Form for Comments
Operating Experience Feedback for Nuclear Installations (DS479)

COMMENTS BY REVIEWER				RESOLUTION			
Reviewer: Mr. M. Smit Country/Organization: The Netherlands / ANVS (RB)		(1 page) Date: July 2016					
Comment No.	Para/Line No.	Proposed new text	Reason	Accepted	Accepted, but modified as follows	Rejected	Reason for modification/rejection
1	p.6 footnote 1	Add the red words in the next sentence: “OE includes for example reportable and non-reportable (including low level) events, operational records, near misses, good practices, organizational factors with direct relevance for safety , and all other information pertaining to the nuclear installation”	To stress that OE is not only about technical topics (as outcomes). For example bad engineering or a bad license application by the operator, could influence safety or could be a precursor for more organizational issues.			x	In line with position of editor, an event definition from IAEA Safety Glossary was used in the revised draft that covers also OE, see footnote 3 page 6

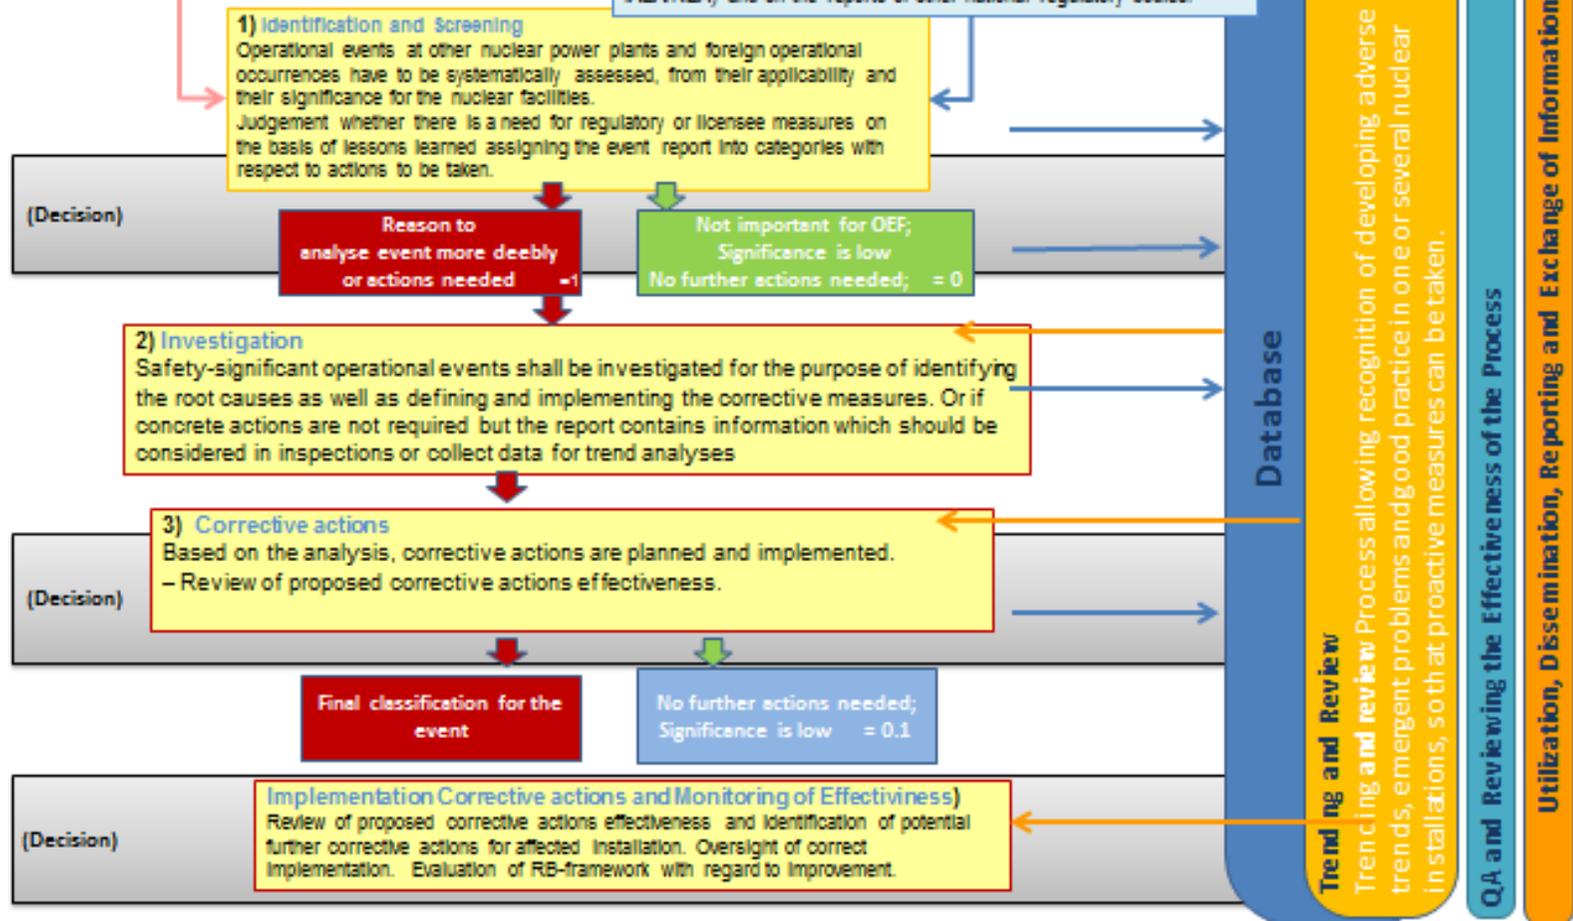
Examples: 1.9, 2.1, 2.5, 2.8, 2.31, 2.46, 2.58, 2.70, 2.82, 2.83, 2.84, 2.89, 3.1, 3.6 3.9, 3.11 and 3.26	throughout the guide.			
3.	Fig. 1	See Attached proposal for updated Figure 2 and reasoning.	<p>The figure should be in line with the text. The updated figure in in line with the text and follows the structure of the safety guide.</p> <p>The example of Fig 2. Is given for the regulatory body. For the Fig. 1. this figure should be modified to reflect the licensees actions.</p>			X	<p>The designation for figure 1 and 2 is changed to ... schematic diagram ... That expresses better the intent of these figures to allow a general conspectus of chapter 2 and 3 at a glance.</p> <p>Member states might have different flow charts in use to reflect the necessary actions according to their management system.</p> <p>Basis for the the proposed flowcharts can be found in several IAEA publications, e.g PROSPER Guidelines, TECDOC 1653.</p>

4.	Fig. 2	See Attached proposal for updated Fig.2.	The figure should be in line with the text. The updated figure in in line with the text and follows the structure of the safety guide.		X		The texts in 3.7 and in the Figure 2 were aligned.
